CHANGE MANAGEMENT

SAMPLE: substantiate Cause-Effect-Relations
constitute exhaustive Evidences

2. Contractor Commence Excavation

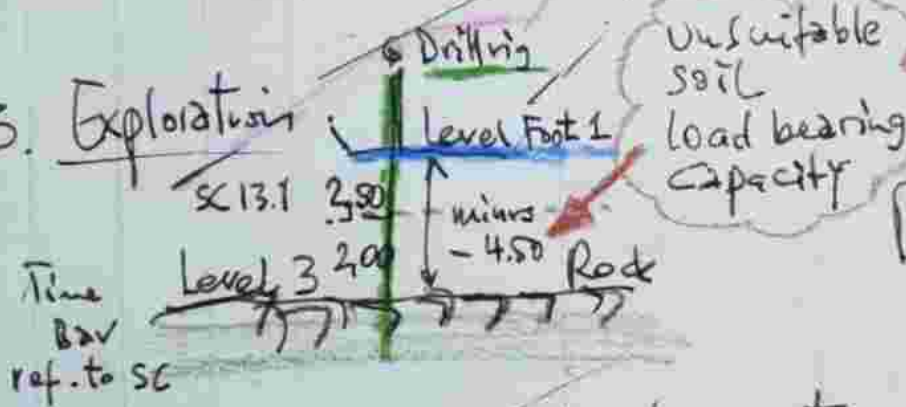
3. Exploration

Instruction Engineer
Replace soil - 2.50
Test Compaction, fails
Replace soil - 4.50
up to Rock level
Testing ... Result F/P.

4. Excavation up to soil replacement according drawing.

Instruction to Rock level.
